UNITED STATES PATENT AND TRADEMARK OFFICE

APPLICATION NO.	FILING DATE	FIRST NAMED INVENTOR	ATTORNEY DOCKET NO.	CONFIRMATION NO.
09/553,573	04/19/2000	Gary K. Michelson M.D.	101.0077-00000	3776

## Office Action Summary

## DETAILED ACTION

FIG. 2

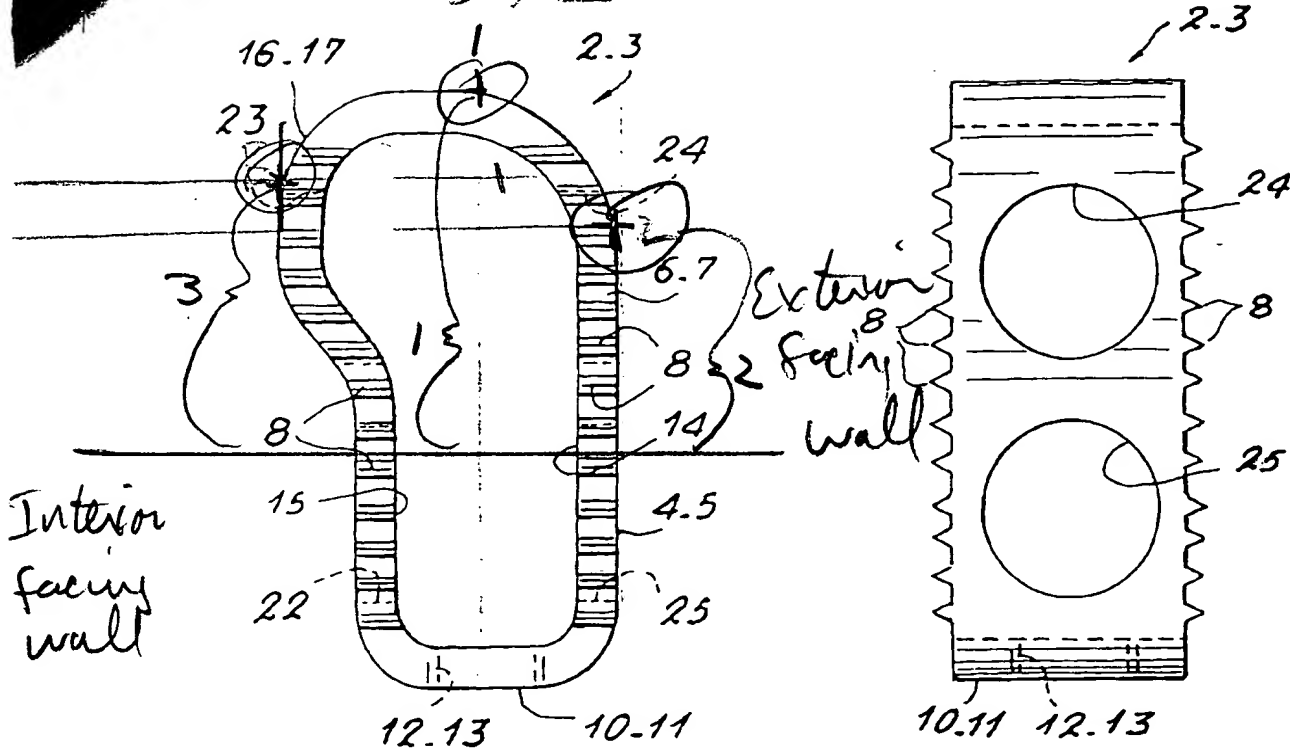
Referring to figure 1, Albert teaches a spinal implant having a width approximately  $\frac{1}{2}$  of the maximum width of the vertebral into which it is intended to be implanted. The implant has a first distance that is greater than a second distance and a third distance greater than said second distance. See attachment of Figure 2 with the Examiner's interpretation.
